**DEVIATION REQUEST
AND DECISION FORM**

Project Name : Hillside at Lorson Ranch
 Schedule No.(s) : 5500000370, 5500000371, 5500000405, 5500000281, 5500000282, & 5500000283
 Legal Description : See Attached

A deviation from the standards of or in Section 2.2.5 (E) of the Engineering Criteria Manual (ECM) is requested.

DEVIATION 1
 EXHIBIT

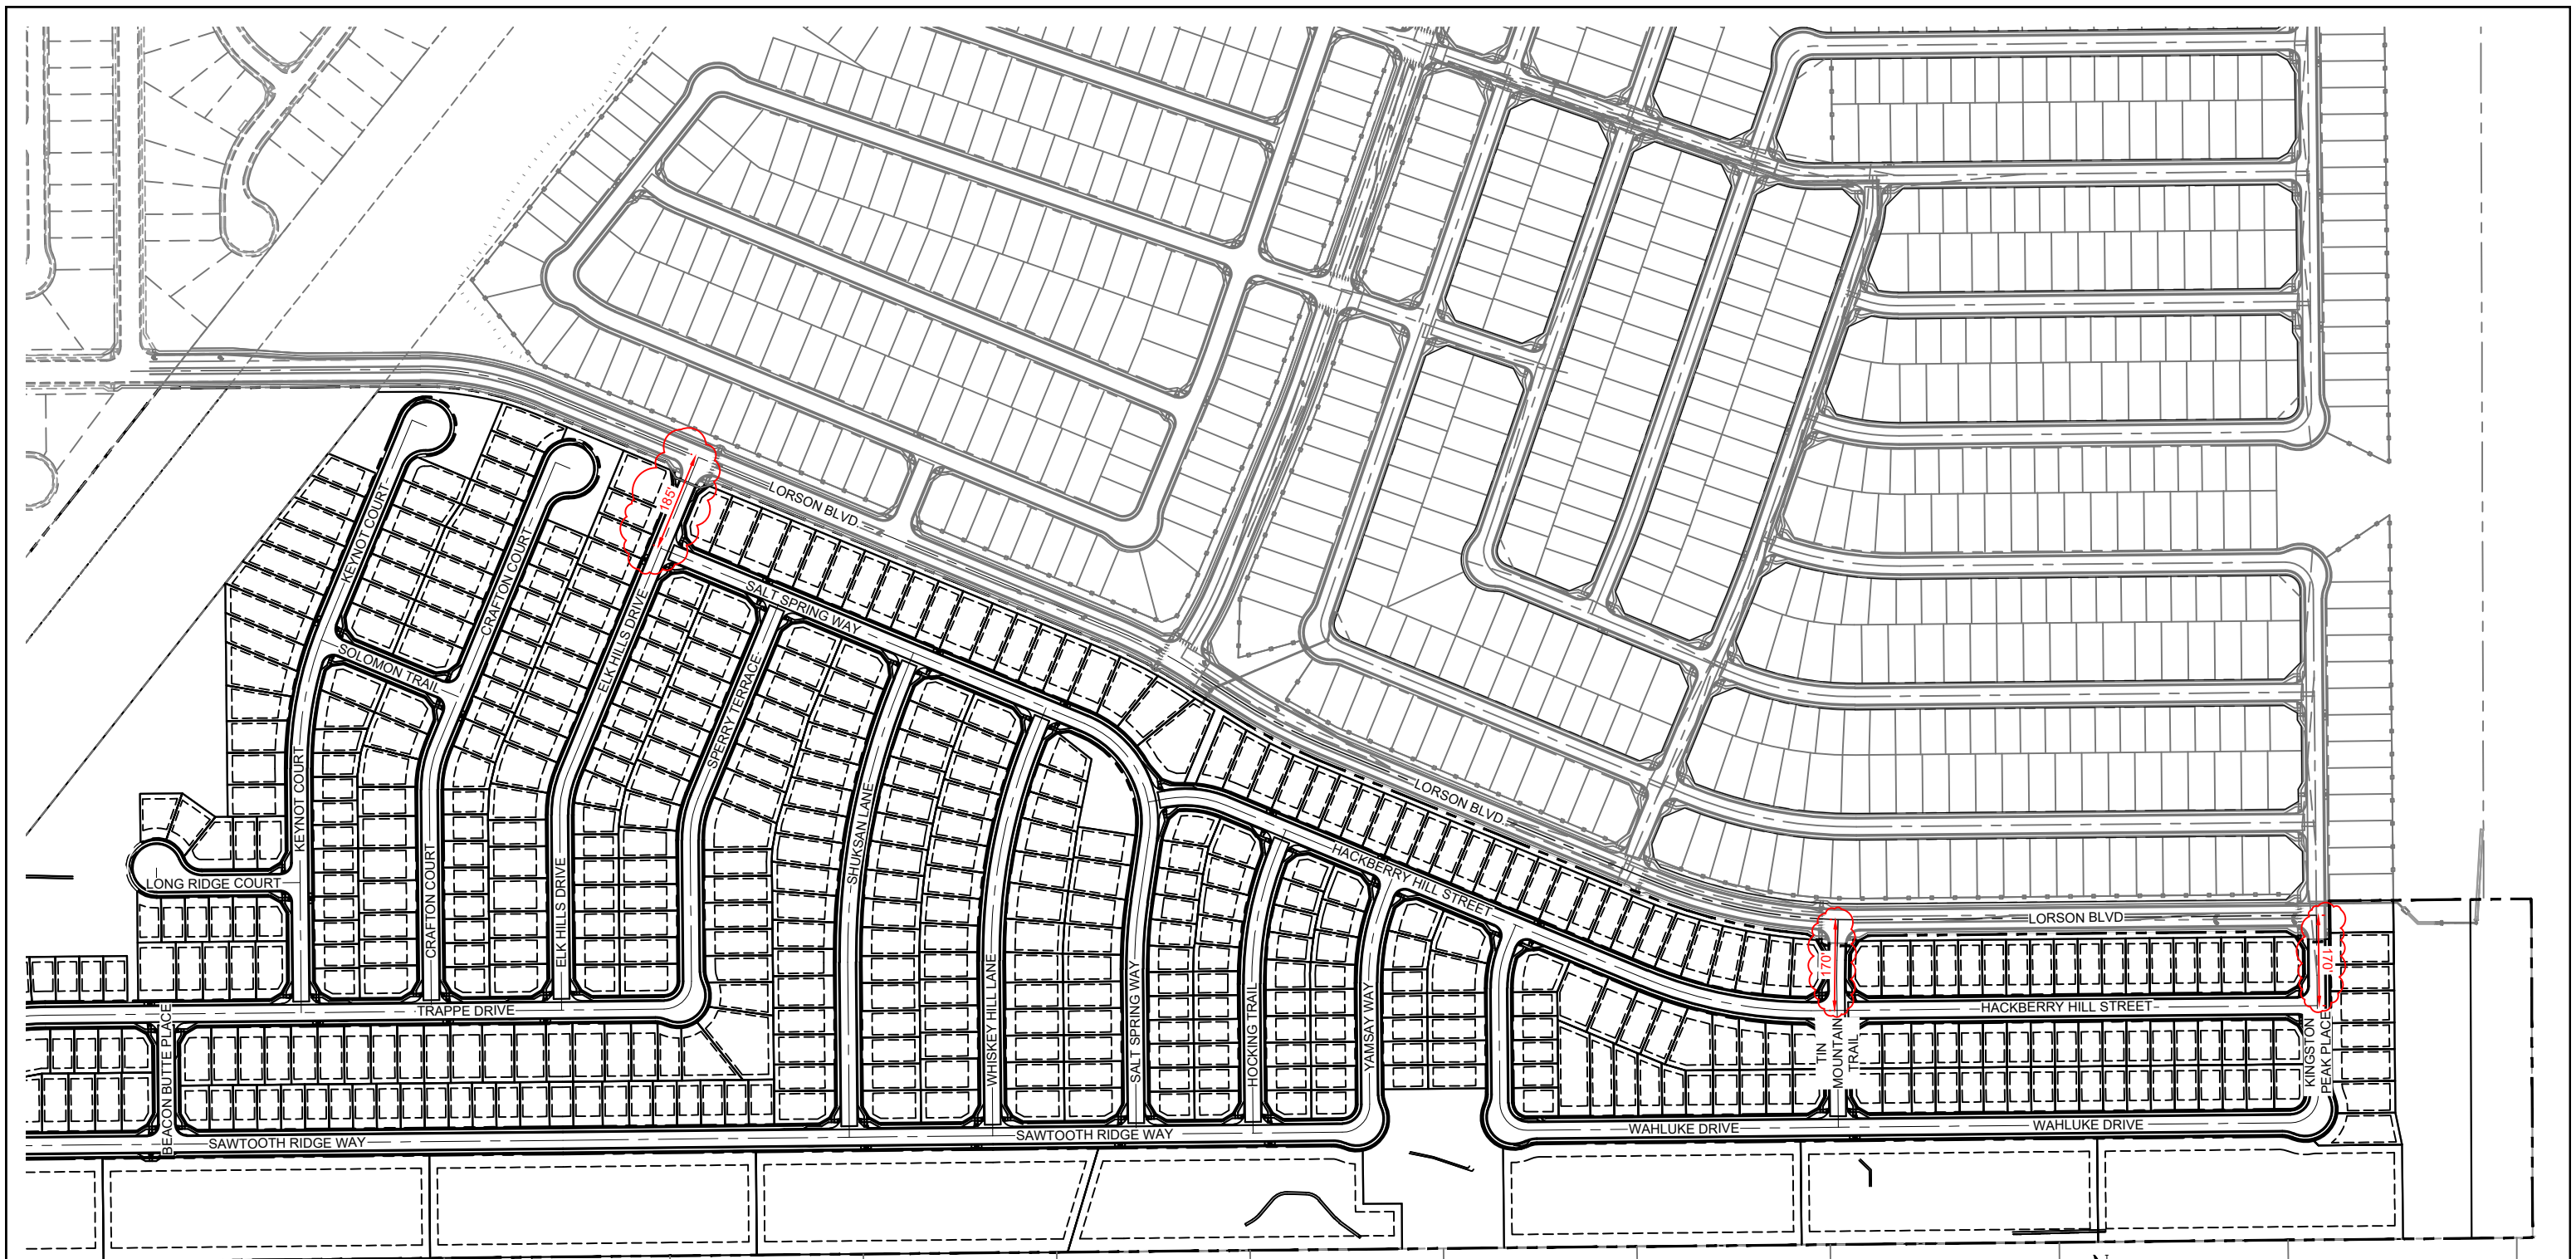
To permit urban local roadways and a collector roadway to intersect centerline to centerline closer than 200'.

Lorsen Boulevard, the intersecting road, is proposed as a residential collector. Per the 200' spacing requirement, in order to meet the standard the lots would have to be 133'-135' deep in this instance. A 170'-185' intersection spacing is currently proposed at the three intersections along Lorson Boulevard.

The modification to permit roadway intersections less than 200' will not adversely affect safety or operations as these intersections are not designed as through streets, limiting traffic to residents. The intersection spacing as shown at the intersection of Kingston Place & Lorson Boulevard is 170'. The intersection spacing as shown at the intersection of Tin Mountain Trail & Lorson Boulevard is 170'. The intersection spacing as shown at the intersection of Elk Hills Drive & Lorson Boulevard is 185'. Given the limited traffic and cut through options, the shortened intersection spacing is not expected to cause any queuing constraints. In addition, pedestrian safety should not be comprised as any vehicle entering the site will have done so after a complete stop or near complete stop keeping speeds at a minimum when approach the intersection crossings.
